DRAFT Response to Comments on the Savannah Harbor Hydrodynamic and Salinity Model Acceptance Package: Part IV

Computational Hydraulics and Transport, LLC (CHT) for US Army Engineer and Research Development Center (ERDC) Comments (Billy H. Johnson)

Figure 1-1. 1999 simulated vs. observed surface and bottom salinity at station GPA-04 for the calibration scenario.

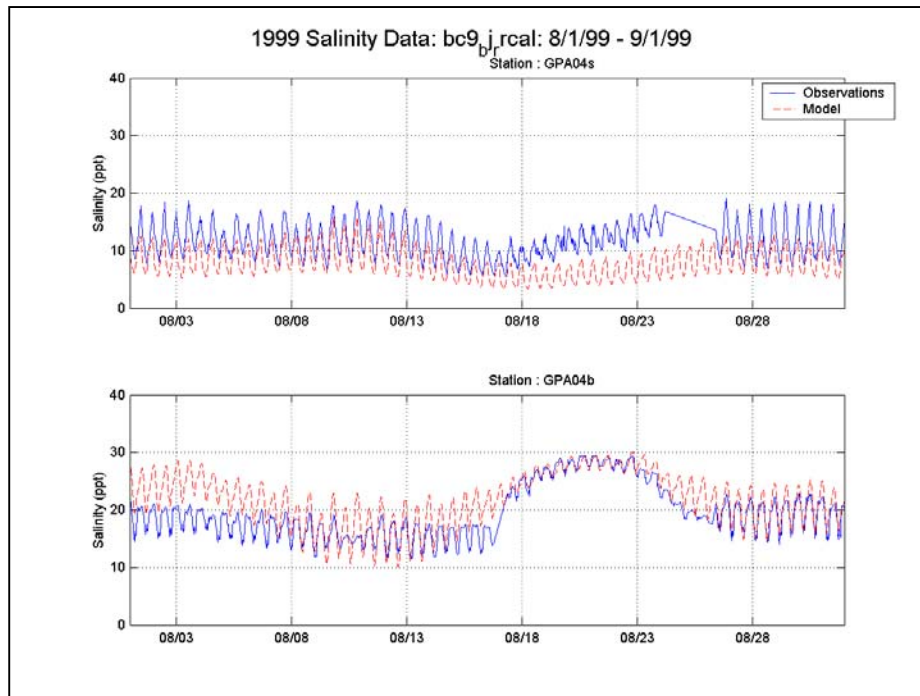
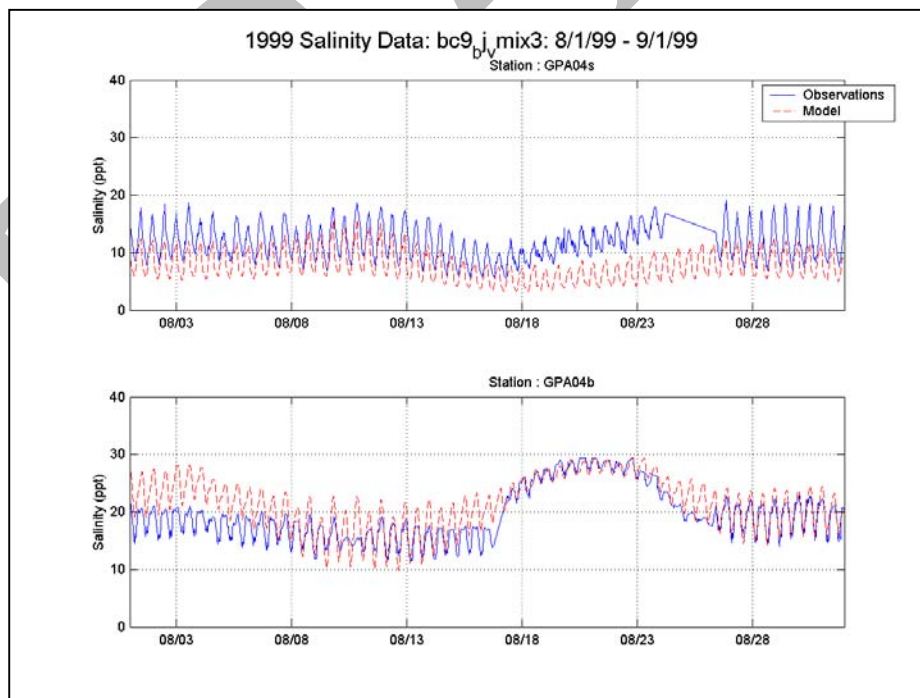
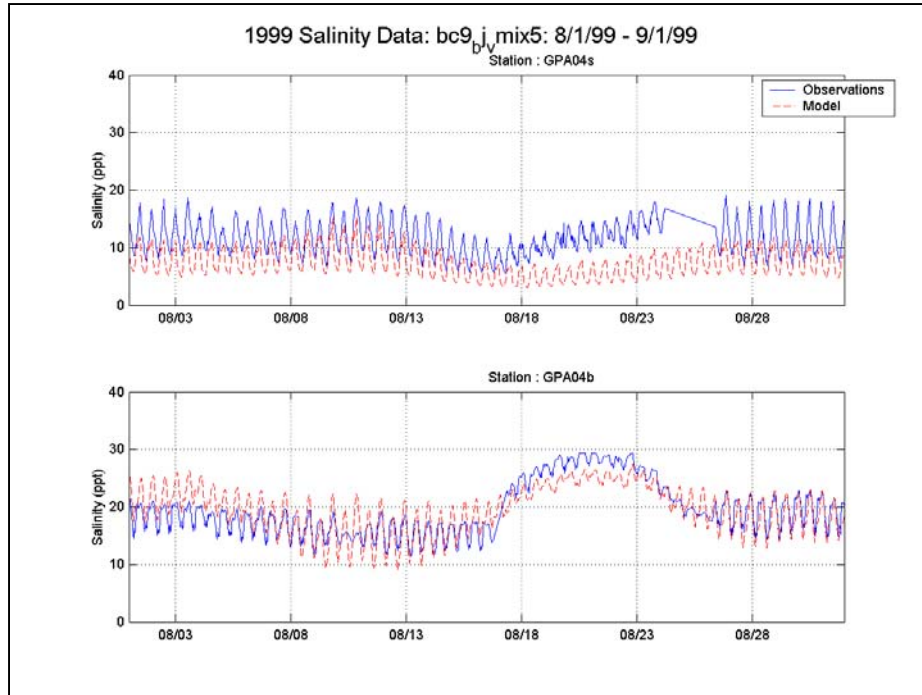
Figure 1 shows the locations of several salinity stations. An inspection of the salinity plot at Ft Jackson (Figure 2) shows that the model computes bottom salinities that are too high and surface salinities that are too low. In a previous laterally-averaged modeling effort of the Savannah Estuary by Johnson, Trawle, and Kee (1989), it was concluded that the vertical diffusion of salt in the ocean part of the grid needed to be increased over that in the estuary. If the turbulence closure scheme is modified to result in increased vertical diffusion in the ocean part of the current 3D model, the computed salinity profile moving into the estuary will likely match the field data better. However, accomplishing this will not result in a significant improvement of the model being able to capture the tidal dynamics of salinity transport.

The results of the tests are shown in the Figures below. Figure 1-1 shows a detail of the predicted vs. the observed salinity at station GPA-04 at the surface and bottom for the calibration scenario during the month of August 1999, for reference. Figures 1-2 and 1-3 show the same data for increased vertical mixing offshore cases VMIX3 and VMIX5, respectively. Cases VMIX3 and VMIX5 represent factors of 2 and 6 times the offshore mixing calculated in the calibration case and cover the range of additional mixing tested.

Reviewing Figures 1-1 through 1-3, it can be seen that the mixing does influence the salinity concentrations at GPA-04 but tends to decrease the bottom salinity, resulting in some improvement for scenario VMIX3, but unfortunately without a corresponding increase at the surface, which was the other half of the desired result.

Figure 2-1. Model predicted volume flux comparison to observations.

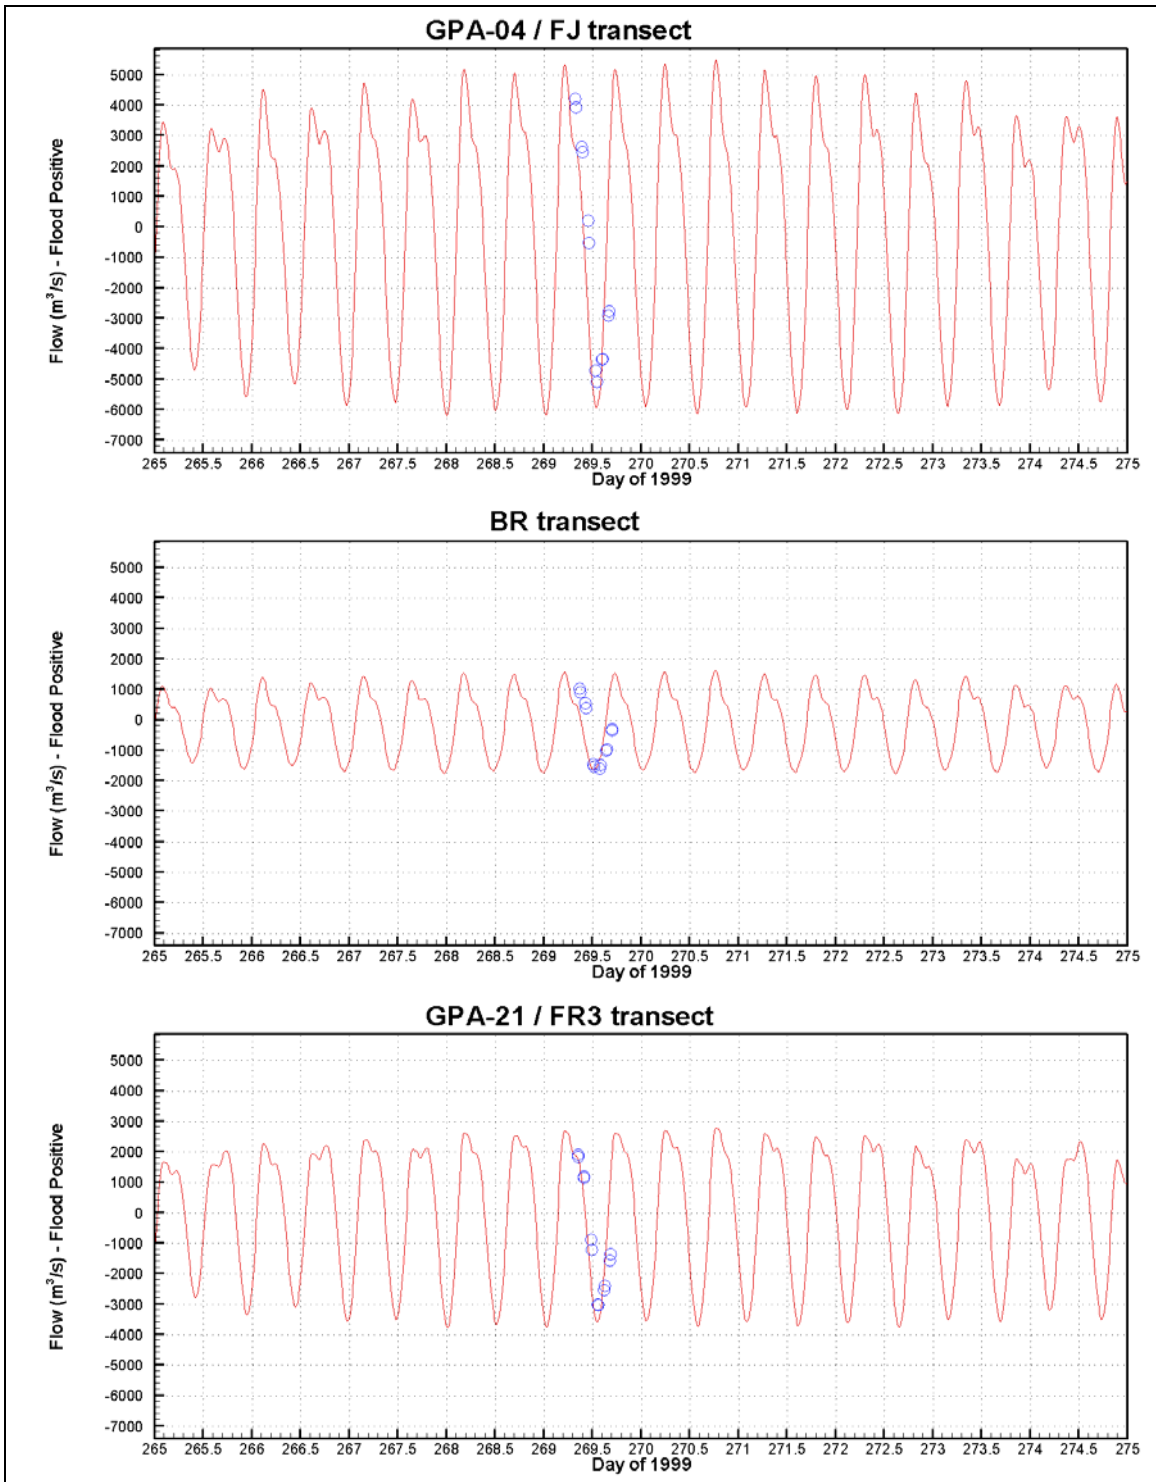
The second comment relates to the distribution of flow near Ft Jackson. ADCP measurements were made at the locations shown in Figure 3. From Figures 4-5, it can be seen that the field data for volume flux below the junction of Front River and Back River matches model results quite well. However, it can be seen that model results are totally erroneous for volume flux into Back River. The sum of the flux into Front River and into Back River should be the total flux below the junction. It is hard to believe that the numerical model could remain stable based on the results shown in Figures 4-5. These results need explaining. Are the Transect BR results displayed correctly?

It appears that the commenter is referring to volume flux plots in the Draft Hydrodynamic and Salinity Model Calibration Report (ATM, 2001). Since the distribution of that report a subsequent Hydrodynamic and Salinity Model Approval Package (ATM, 2002) has been issued which included many improvements to the model predictions. In addition a number of plotting errors have been corrected. In the Draft Hydrodynamic and Salinity Model Calibration Report (ATM, 2001), the simulated volume flux plots were unfortunately in error due to a model output post-processing error. The correct simulated and measured flows are shown in Figure 2-1 for day 269 of 1999. The plot demonstrates that the model accurately replicates the flow rates measured in the field.

The commenter notes that the sum of the flux into Front River and into Back River should be the total flux below the junction. This was evaluated by summing the fluxes over a tidal cycle. For the ebb and flood cycles that correspond to the measured data on day 269, the simulated volume fluxes were summed over the ebb and flood tides. The results are tabulated below:

The 12-13% difference in the gross ebb and flood volume fluxes between upriver and downriver transects are accounted for in the tidal storage area between the transects. The storage area is equal to the surface area of the river between the transects multiplied by the tidal range for that particular ebb or flood tide. The surface area between the transects is approximately 3.22 km². The simulated tide ranges over the flood and ebb tides were approximately 2.87 m and 2.84 m, respectively. Therefore, the tidal storage volume between the flow transects is equal to 9.14E+06 m³. This volume is approximately equal to the difference in the integrated volumes shown in the above table. The remaining discrepancy is less than 1% of the flow volume passing GPA-04. This analysis confirms that the model is conserving volume transport.

Figure 3-1. Simulated and measured water surface elevation (WSE) percentiles for the 1999 calibration.

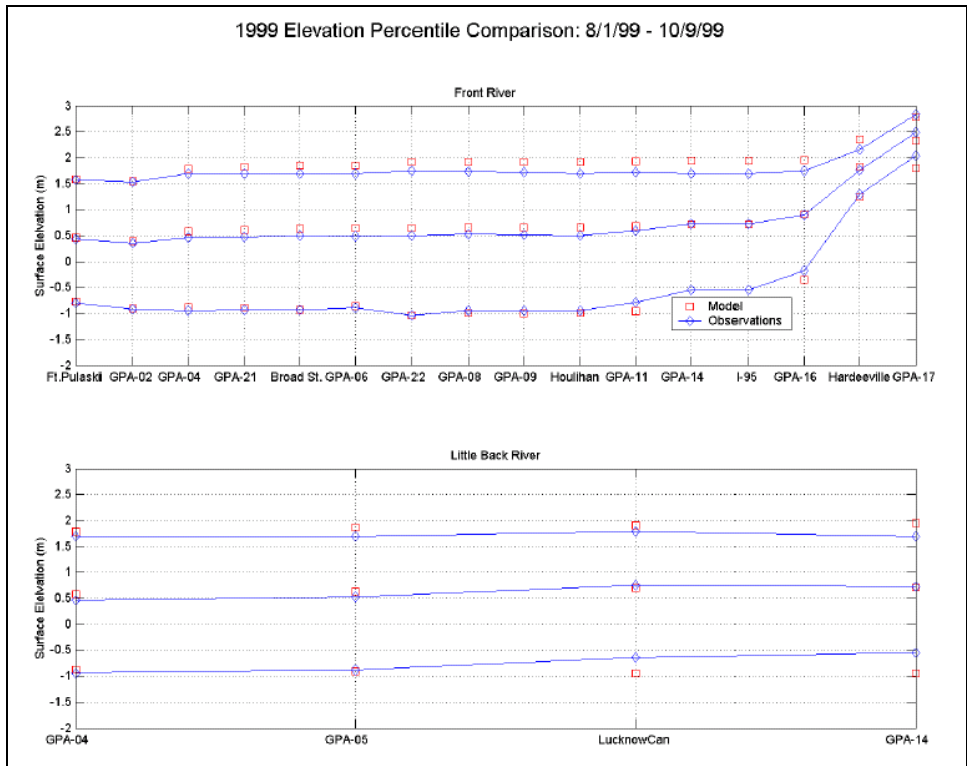
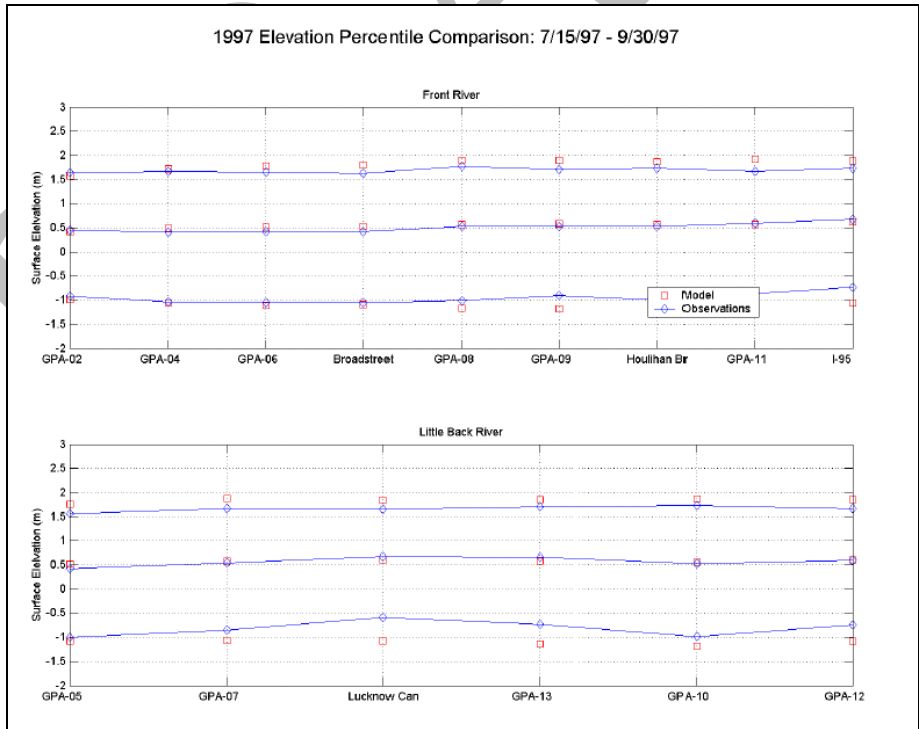
Figure 10 shows the location of Broad Street and the I-95 Bridge. Figure 11 shows that the mean water surface level at Ft Pulaski is reproduced well. However, at the Broad Street Station on Front River, the computed mean water surface is slightly higher than the observed (see Figure 12). At the I-95 bridge, Figure 13 shows that the computed mean water surface level is significantly lower than the observed. Therefore, from the I-95 Bridge to Broad Street, the computed mean water surface slope is much lower than the observed slope. The major reasons for the discrepancy in the water surface slope are likely related to friction, freshwater inflow, and / or the treatment of marsh storage. It is assumed that the freshwater inflow is correct.

The commenter examines the mean water level plots from the Draft Calibration Report and concludes that under-prediction of the mean water level at I-95 may cause poor simulation of the salinity front. Improvements made to the model following the Draft Calibration Report included better simulation of the river slope above Houlihan Bridge. The water levels percentiles shown in Figures 3-1 and 3-2 (taken from the Approval Package, showing the 90th, 50th and 10th percentiles for 1999 and 1997 respectively) show that the model is reproducing the increase in mean water level in the upriver areas.

Figure 3-3. Measured depth averaged currents and instrument depth at GPA-06.

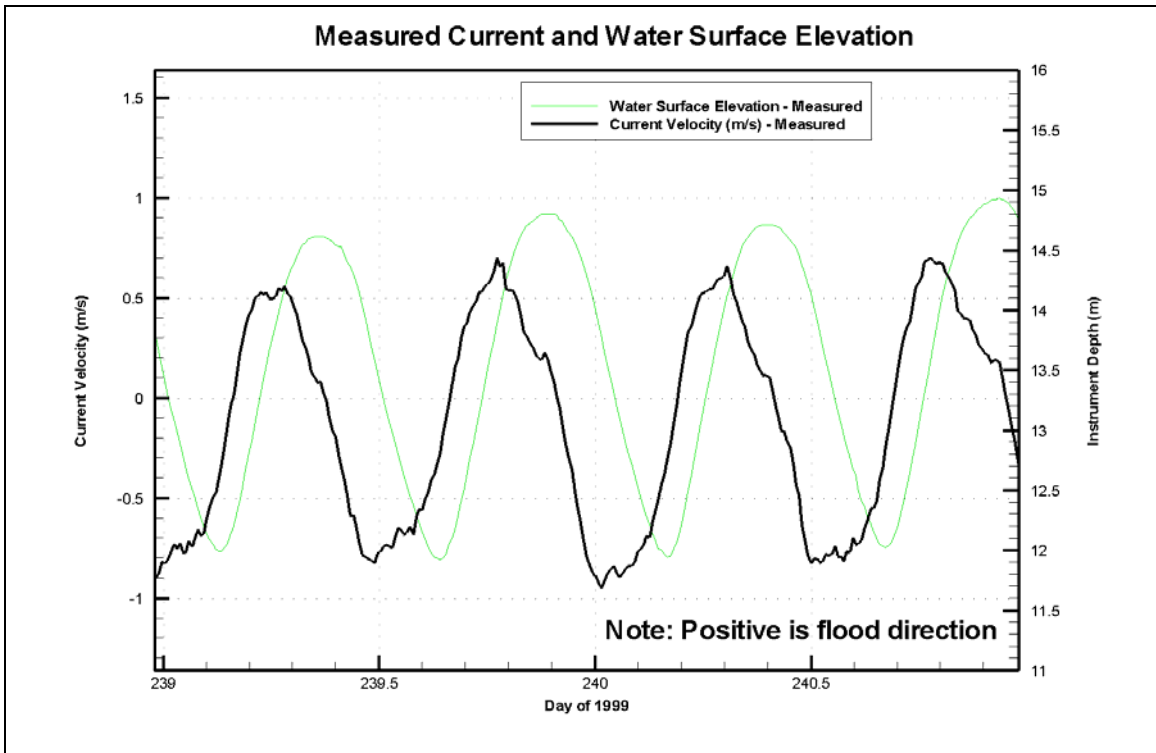
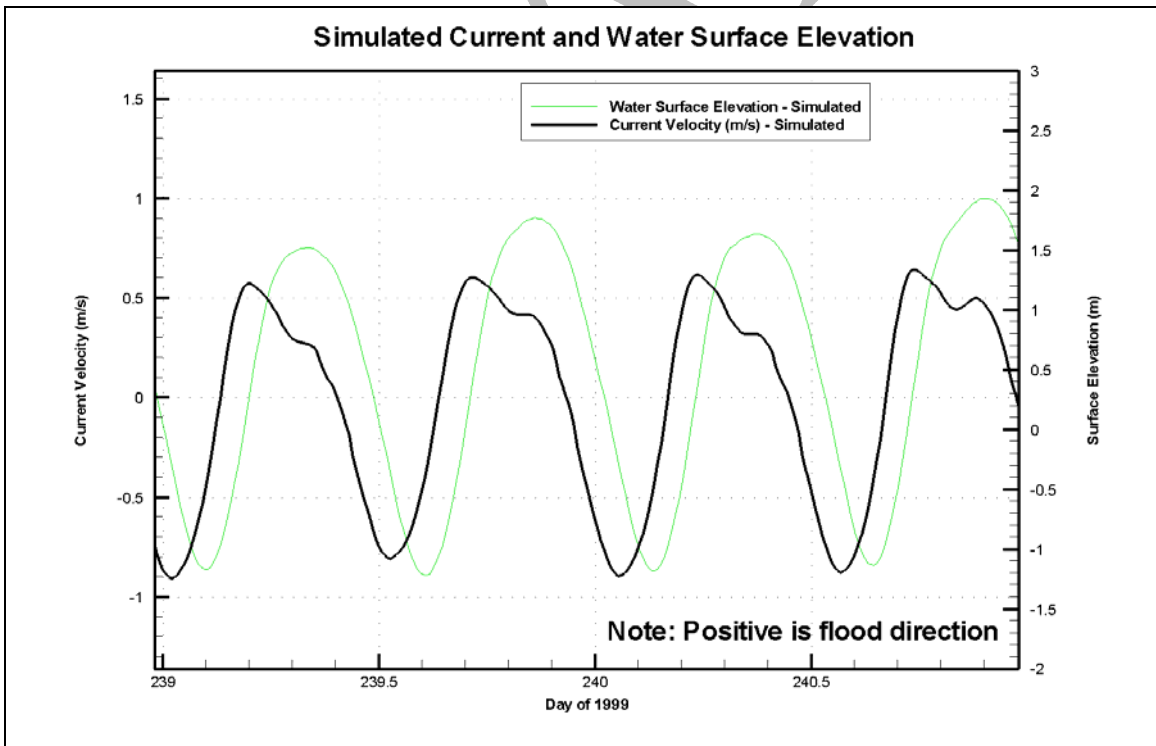
Figure 16 shows that the observed tide at GPA-06 is indeed a progressive wave since the elevation and current are in phase. Note, however, that the computed tide closely resembles a standing wave with the elevation and current out of phase. In addition, it can be seen that the computed water surface elevation has a flatter peak than the observed, indicating that the total amount of marsh area in the model may be too large.

The commenter compares water surface elevation and currents at Station GPA-06 and concludes that the simulated data show a standing tidal wave whereas the measured data show a progressive wave. The conclusion is based on only the GPA-06 current figure in the Draft Calibration Report, which unfortunately, was in error. The GPA-06 ADCP data had timing error for part of the monitoring study that has since been corrected. The measured data in the other ADCP current plots in the Draft Calibration report for GPA-04 (Figures 7-16a, 7-16b, 8-16a and 8-16b) and GPA-08 (Figures 8-17a and 8-17b) show the maximum currents out of phase with the peak water levels, which indicates that the tidal wave in the estuary is not a progressive wave. Instead, the measured data show that it is closer to a standing wave.

The depth averaged ADCP currents and water surface elevation for GPA-06 is shown in Figure 3-3 (for data collected during the 1999 monitoring study). The 1999 measured data show that the tidal wave is close to a standing wave. The simulated currents (Figure 3-4) show that the model is simulating the phase relationship between water surface elevation and currents reasonably well.

Figure 3-5. Simulated WSE at GPA-21 for marsh runs.

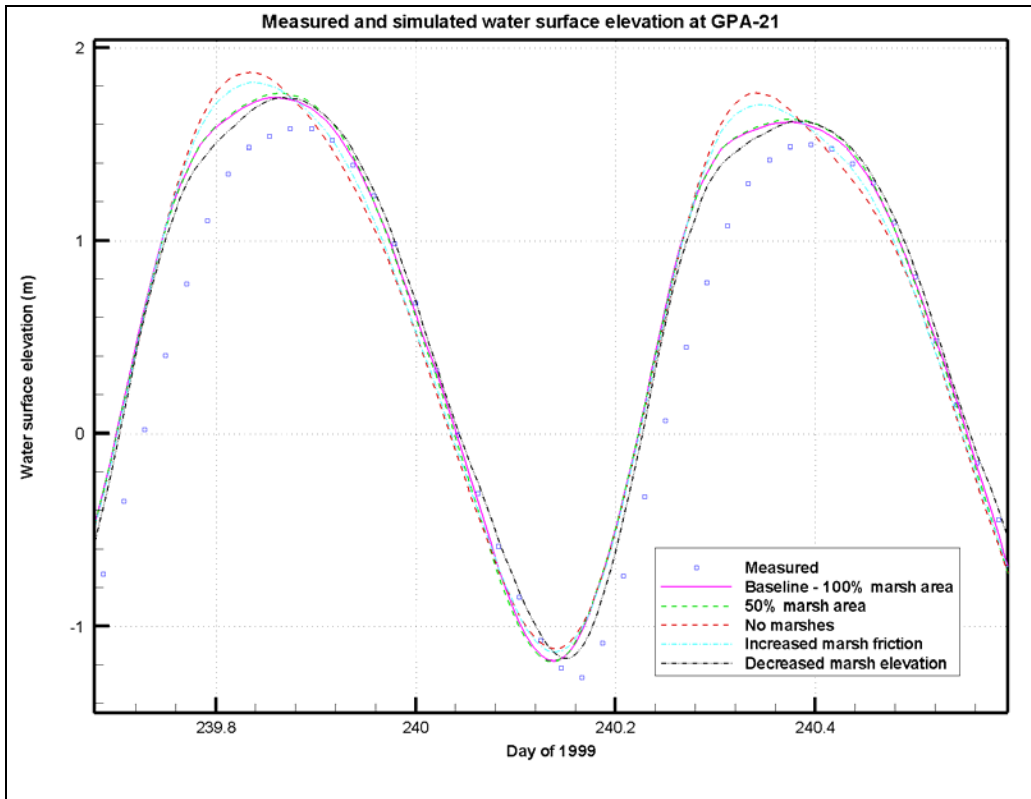
The commenter notes that the peaks of the simulated water surface elevations are flatter than the measured data, which may be caused by excessive marsh storage areas. The commenter also recommended varying the marsh storage area (and other marsh characteristics) to improve the tidal wave characteristics.

The simulation results for water surface elevation at GPA-21 are shown in Figure 3-5. The simulation without marshes is significantly worse for the high tide predictions. Decreasing the marsh area by 50% made no significant difference. Increasing the marsh friction is worse for the high tide predictions. Decreasing the marsh elevation resulted in a slight improvement.
